SERVICE BULLETIN

N° 189-327

ATA 26 - DETECTOR FIRE INSTALLATION AUXILIARY POWER UNIT RETROMOD

Figure 1

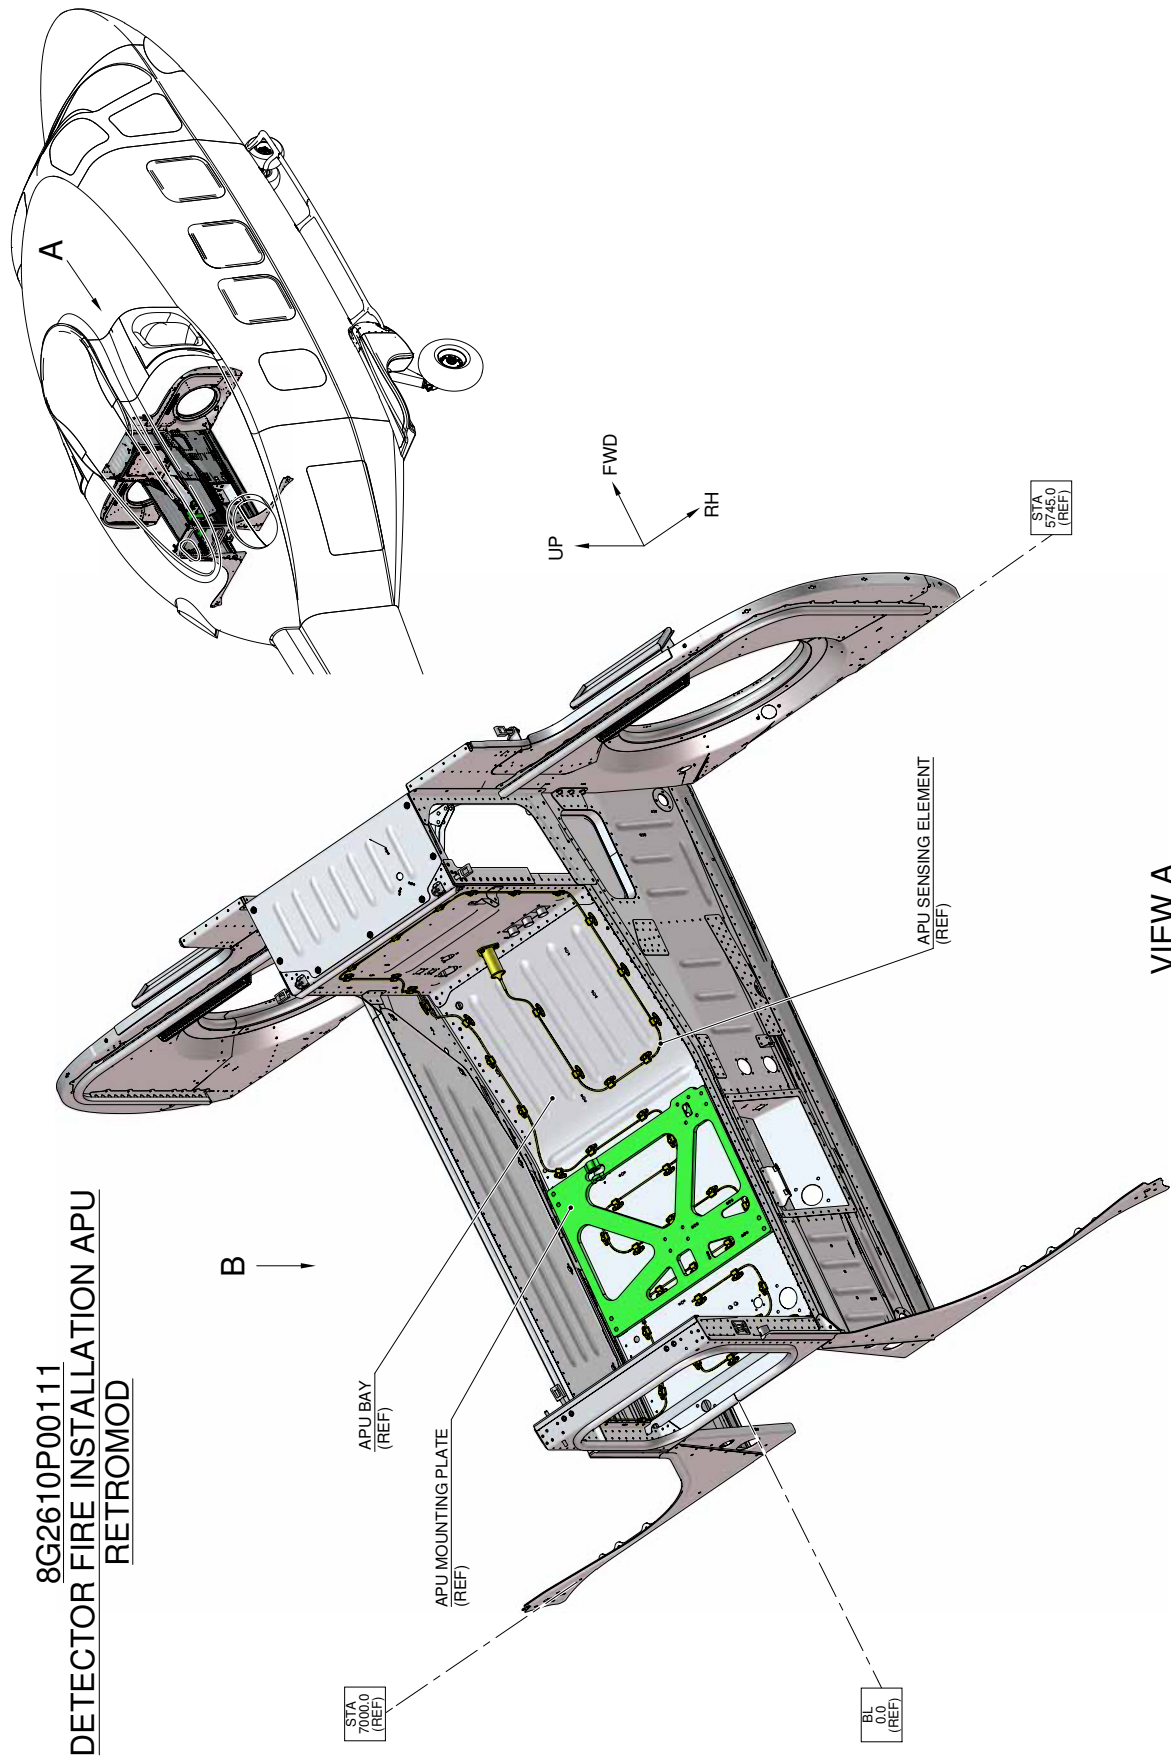
4. With reference to Figure 1, perform an inspection of the APU fire detector sensing element as described in the following procedure:
 - 4.1 Perform a visual inspection of the APU sensing element. Make sure that it is not damaged.
 - 4.2 If the APU sensing element is damaged, verify if the “APU FIRE DET” caution and “APU FIRE DET” maintenance message have been generated on the helicopter; if so, proceed with the following step, otherwise skip to Step 5.
 - 4.3 In accordance with AMP DM 89-A-26-14-01-00A-520A-A, remove the APU sensing element from the helicopter. Discard the APU sensing element.
 - 4.4 In accordance with AMP DM 89-A-26-14-01-00A-720A-A, install a new APU sensing element P/N 6360-24-450/170C-6M on the helicopter.

5. With reference to Figures 1 and 2, install n°10 sensor bushings P/N 3106 by means of sealing compound DAPCO 2100 (C095) in the indicated positions on the APU sensing element. Sealant RTV106 can be used as alternative to DAPCO 2100.
6. In accordance with AMP DM 89-A-49-11-01-00A-720A-A, re-install the auxiliary power unit on the helicopter.
7. Return the helicopter to flight configuration and record for compliance with this Service Bulletin on the helicopter logbook.
8. Send the attached compliance form to the following mail box:

Figure 3

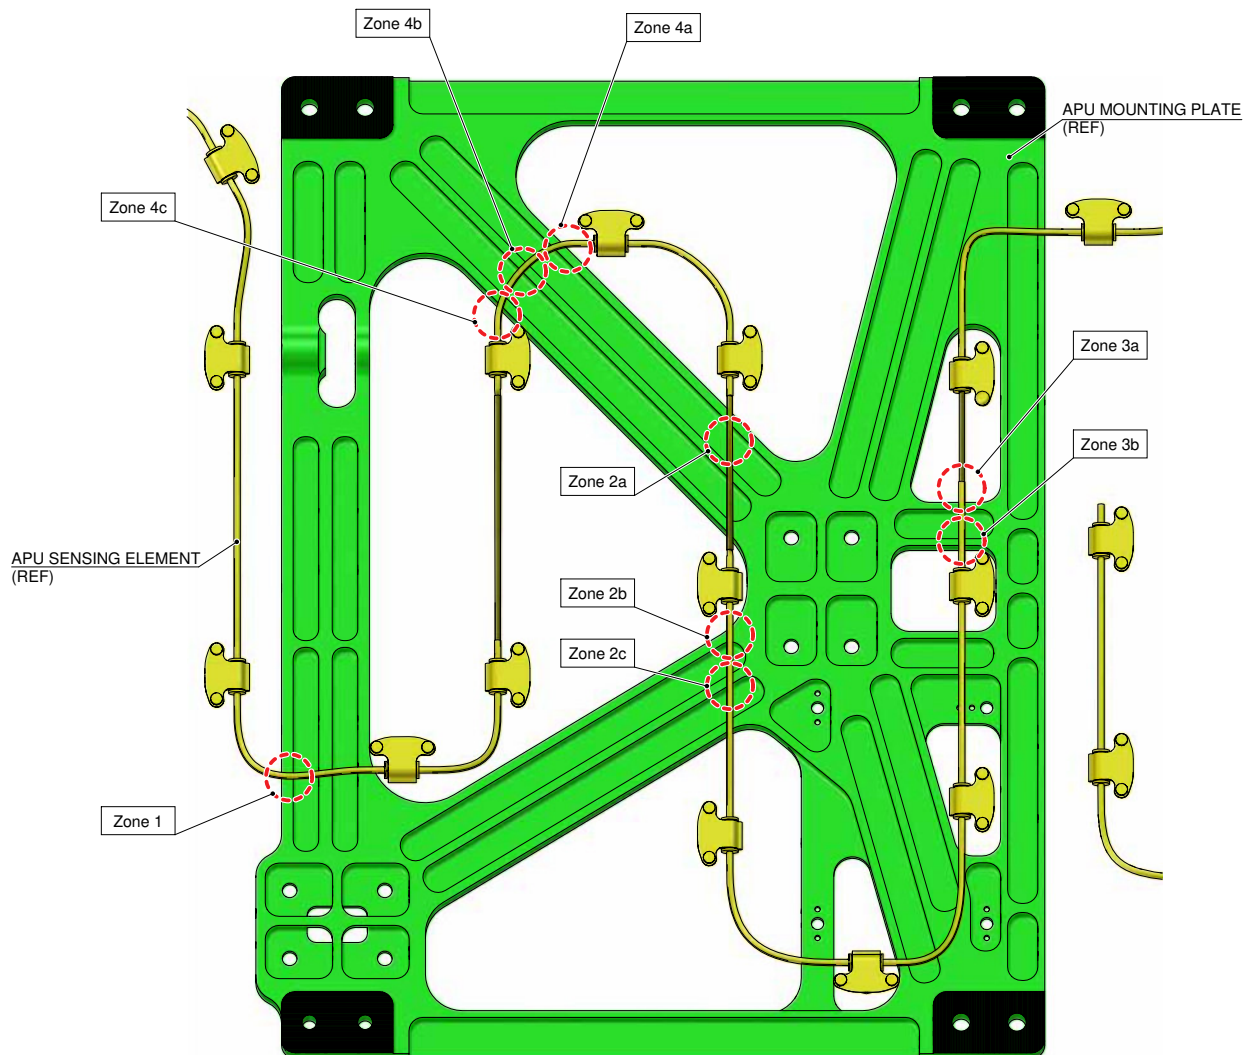
2. In accordance with AMP DM 89-A-49-11-01-00A-520A-A, remove the auxiliary power unit from the helicopter.
 3. With reference to Figure 3, perform a visual inspection to the APU mounting plate as described in the following procedure:

- 3.2 Check for damage to the APU mounting plate in the indicated areas of possible contact between the APU mounting plate and the APU sensing element.

- 3.3.2 If the damage found is within the allowable limits specified on the table in the Figure 3 skip to Step 3.4. Otherwise proceed with the following step.

Zone	MAXIMUM DAMAGE DEPTHS (mm)
1	1.00
2a	0.80
2b	0.20
2c	0.40
3a	1.00
3b	1.00
4a	0.15
4b	0.12
4c	0.10
